In response to review comments for the Laramie County Community College project, dated October 21, 2005, Taylor Kohrs responses are listed below.

In response to review comments, dated October 21, 2005, Taylor Kohrs is requesting Administrative Relief on two (2) separate items on the Laramie County Community College project.

Encl: Reduced Site Plan, A100

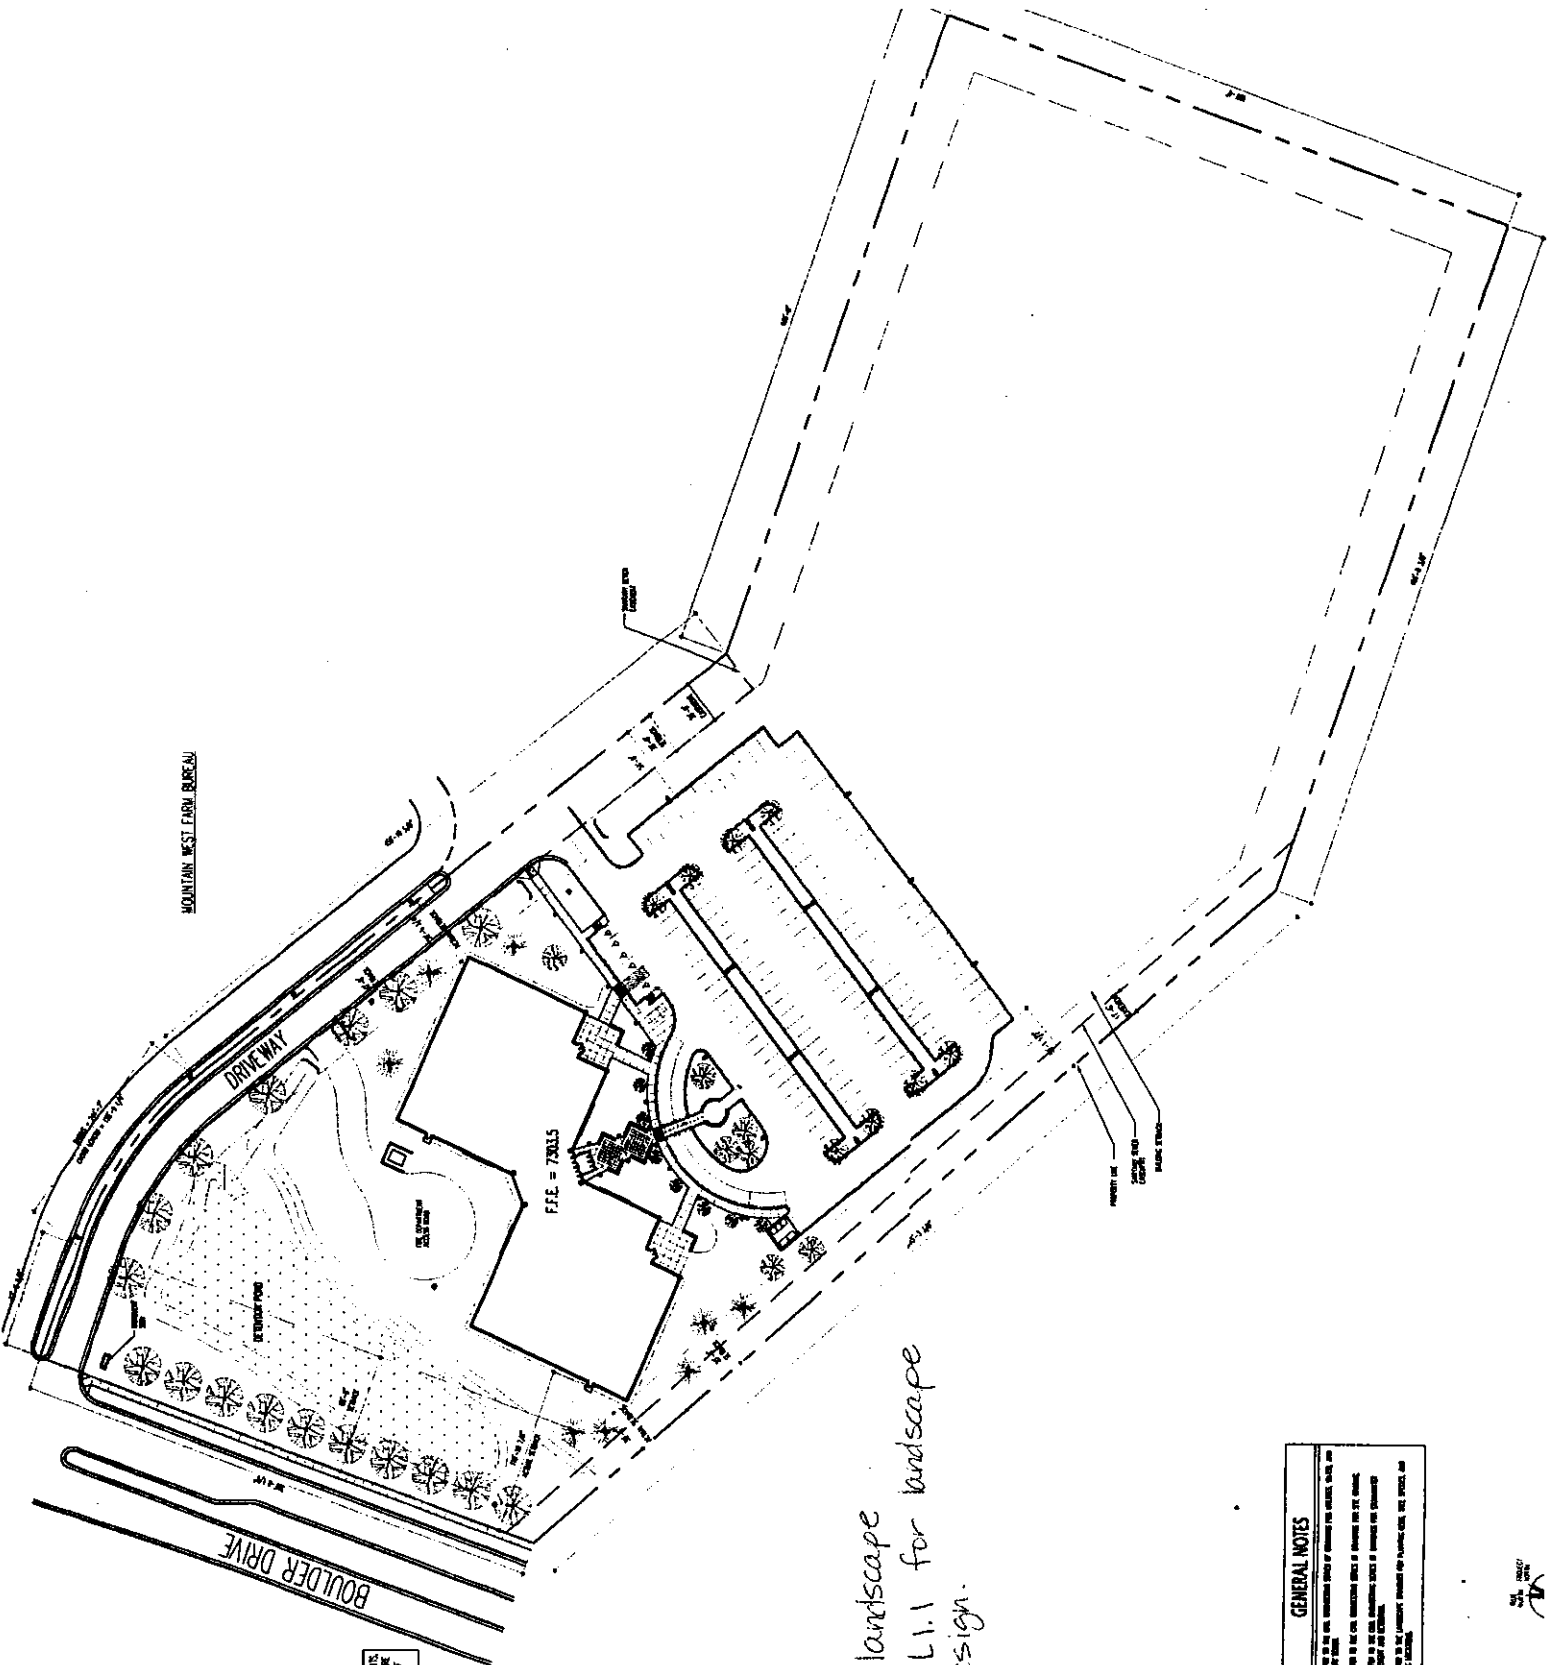
General Comment #7 – “The City zoning ordinance requires additional landscaped bufferyards along all non-street property lines.” At this time, the Owner requests relief for the bufferyards requested at the three (3) additional lot lines, as the adjacent lots are not developed, as well as the remaining half of the LCCC property. Development of these bufferyards is not warranted within the remaining portion of the property as it is undeveloped and would appear odd to have plantings in the middle of an undeveloped area. Irrigating such plantings would also be extremely difficult. Nevertheless, the intent of the landscaping standards and the bufferyard requirements in essence are preserved and it is understood that once these areas are developed, bufferyards would be installed by LCCC in accordance with the code requirements.

Curb and Gutter reduction – Relief is requested for the reduction of curb and gutter at parking areas. Curb and gutter will be installed along both sides of the shared drive and transition from asphalt to sidewalk only. At other areas, parking blocks will be used to separate landscaping from parking areas. Thus, landscaping would be kept as safe from vehicle traffic and the landscape areas would be preserved. In addition, the reduction of these curbs and gutters help the owner to obtain a LEED™ Credit. Eliminating the curb and gutter allows stormwater runoff to be naturally filtered of pollutants and percolate into the ground water.
